Technical Bulletin

Bulletin Number: 459 Revision Number: R-00
Release Date: Oct. 29, 1992 Revision Date: _____

SUBJECT: TRIM FOR ACCESS HOLE OF REAR CONDENSER BAFFLE

MODELS AFFECTED: All Models With Permanent Baffling System

Trim
#801,807,100.21

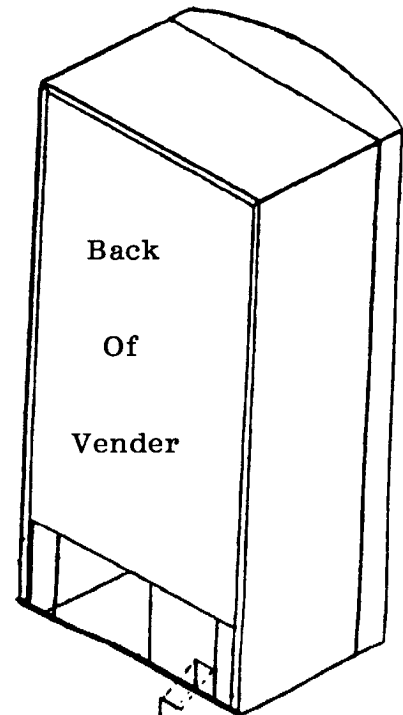
REASON: To provide trim to cover metal edge of the access hole of the rear condenser baffle.

SERIAL BREAK: Beginning serial number 0001-6099DQ and up, the trim for the access hole will be factory installed.

1. Locate access hole on back of vender.
2. Bend the trim in a "L" shape to match the metal edge of the access door.
3. Snap trim in position over the metal edge of the access hole.

IMPORTANT: On some venders the trim may be too long. The trim can be cut to fit these venders.
